PIC10F220-E/OT

PIC10F220/222 Rev. A Silicon Errata

1. Module: Analog-to-Digital (A/D) Converter

FIGURE 1: TYPICAL DNL AT 2.0V (TESTING AT 7-BIT LEVEL)

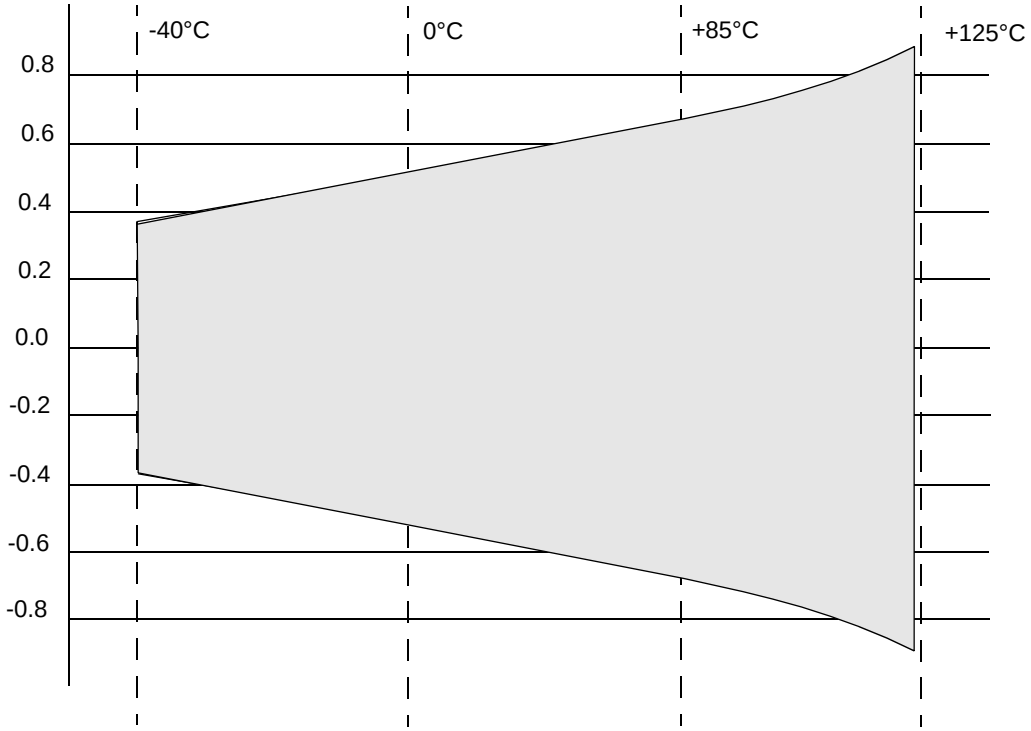
PIC10F220/222 silicon Rev. A1. The A/D Converter does not meet the design target. The specifications listed below in Table 10-6 supersede Table 10-6 in DS41270B.

Note 1: For example, at 0°C the DNL will be between -0.5 and +0.5.

2: For testing at 7-bit level, ADRES <0> is ignored.

FIGURE 2: TYPICAL DNL AT 5.5V (TESTING AT 7-BIT LEVEL)

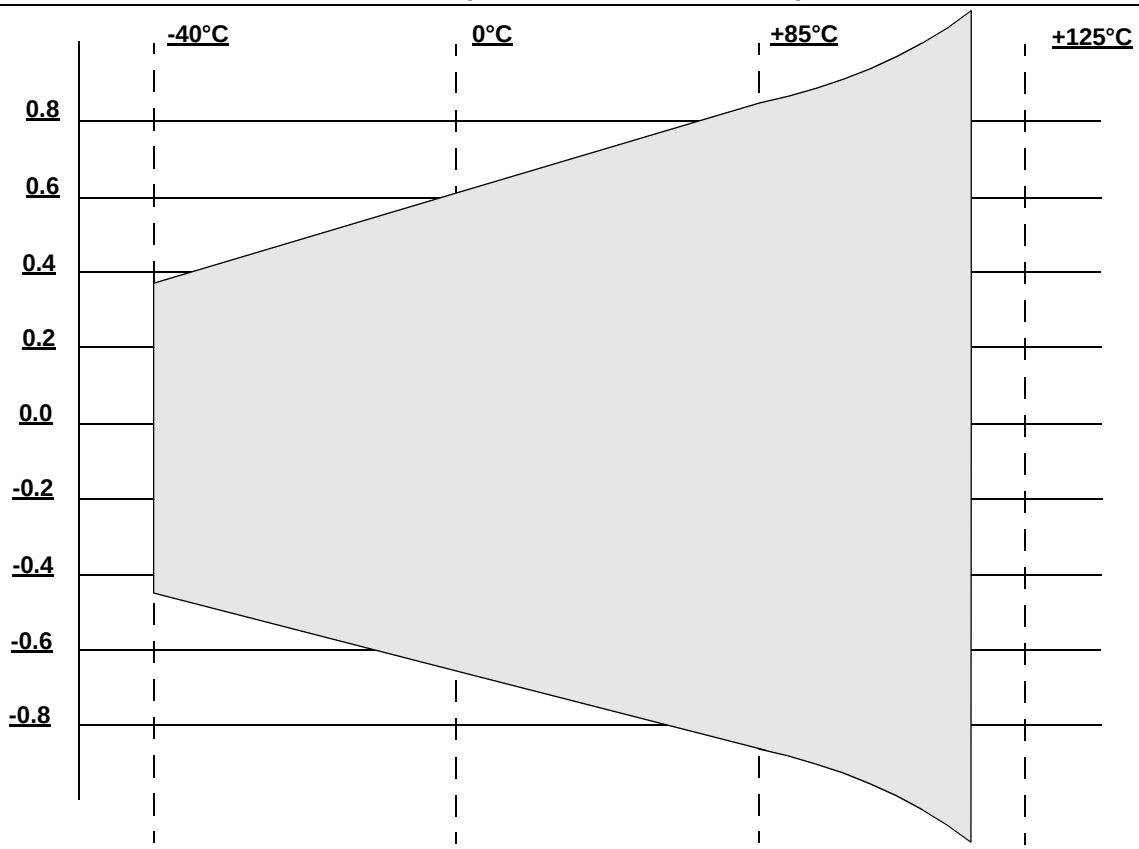
Note 1: For example, at 0°C the DNL will be between -0.7 and +0.6.
2: For testing at 7-bit level, ADRES <0> is ignored.
